Project Name: Replat of lot 13, Valley West Sub #12

REVIEW COMMENTS

FILE #MS-95-215

TITLE HEADING: IBX Minor Subdivision

IBX SUBDIVISION

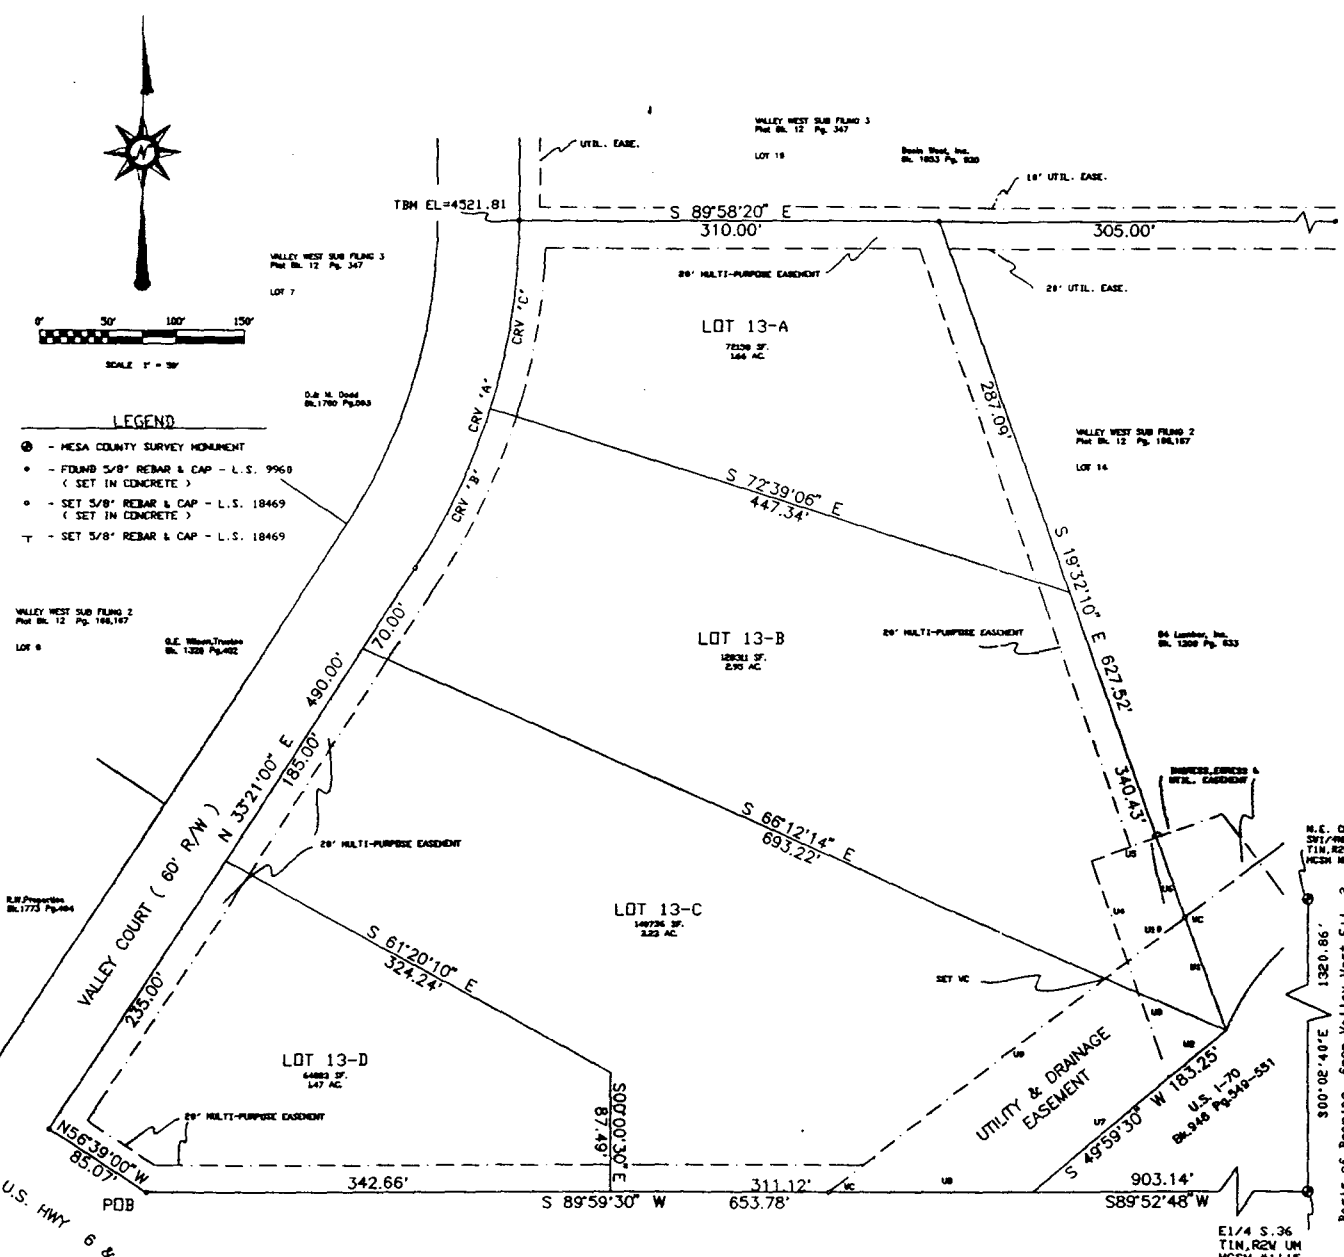
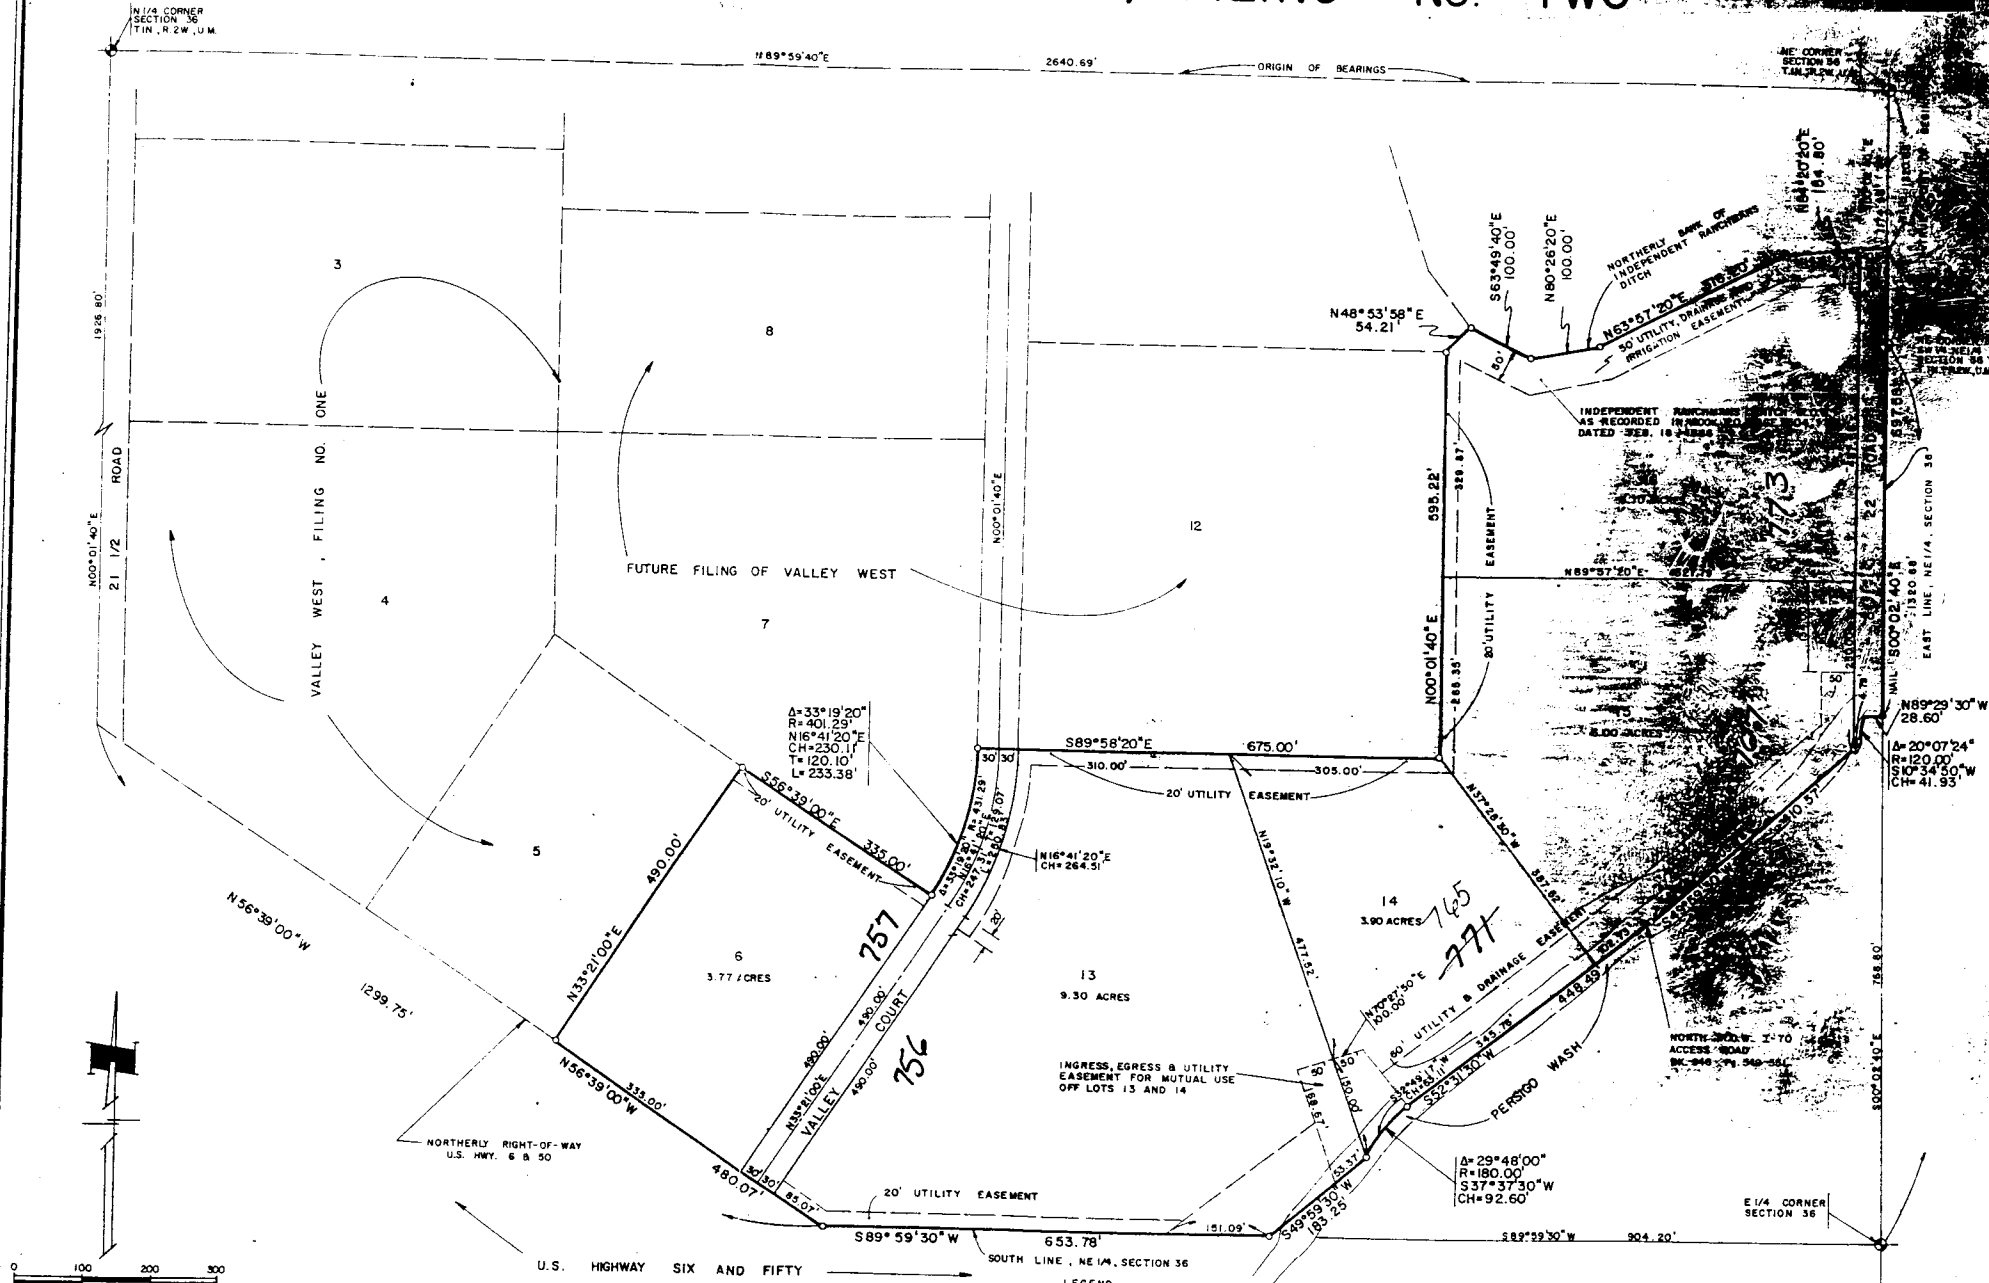
The dedication statement is not clear concerning easements. The City is not always the service provider yet some of the easements are dedicated to the City. On the other hand, the utility and drainage easement is to the property owners/homeowners association. What rights do all of the upstream properties draining into Persigo Wash have? The wash is there! In fact, the District has an easement dating from May 24, 1918, recorded in Book 230 at Page 11 that should be acknowledged on the plat.

What language on the plat assures the future owner of Lot 13A that drainage from that land can flow across Lot 13B? Where does/will the drainage from Lot 13A hit a natural watercourse? Along what route?

1. The utility and drainage easement needs to be described in the dedication.
2. The ingress-egress and utility easement needs to be described in the dedication (who uses this easement?).

1. On-site detention is a requirement for development of the proposed lots. Unless this applicant intends to pay for the improvements alluded to in the conclusion of the drainage report to allow for undetained flows, the detention requirement will be imposed and should be noted in the file for future development considerations.
2. If the intent of the 20' multi-purpose easement is to also allow for drainage conveyance, the dedication language needs to be modified to include drainage.
3. Since a utility and drainage easement is shown, the dedication needs to include utility.
4. The statement regarding streets and rights-of-way is not necessary and needs to be stricken from the dedication.

The drainage concerns within the internal Lots will be addressed and resolved as the Lots are developed. The actual development of each Lot requires a grading and drainage plan be submitted to the Community Development Department of the City of Grand Junction. Multi-purpose easements will provide for potential drainage conveyance. The easement recorded in Book 230 at Page 11 will be acknowledged on the Plat. The easement along Persigo Wash was acknowledged by the original Valley West Subdivision.

- 1) Language identifying and clarifying the utility and drainage easements will added to the dedication. The inclusion of drainage purposes into multi-purpose easements is also noted.
- 2) The ingress-egress and utility easements are pre-existing. Their establishment by recorded instrument will be noted on the Plat.

- 1) At such time as the individual Lots are developed, a grading and drainage plan will be submitted. This plan will hold open any options to improve existing drainage conveyances that may eliminate the need for on-site detention. This option will be at the cost and responsibility of the individual developer. Multi-purpose easements shall include the right to install drainage conveyances should they be required.
- 2) The intent of the 20 foot wide multi-purpose easement is to allow for drainage conveyance and the dedication language has been modified.
- 3) The language to include utility has been added to the dedication.
- 4) Language referring to street right-of-way has been stricken from the dedication.
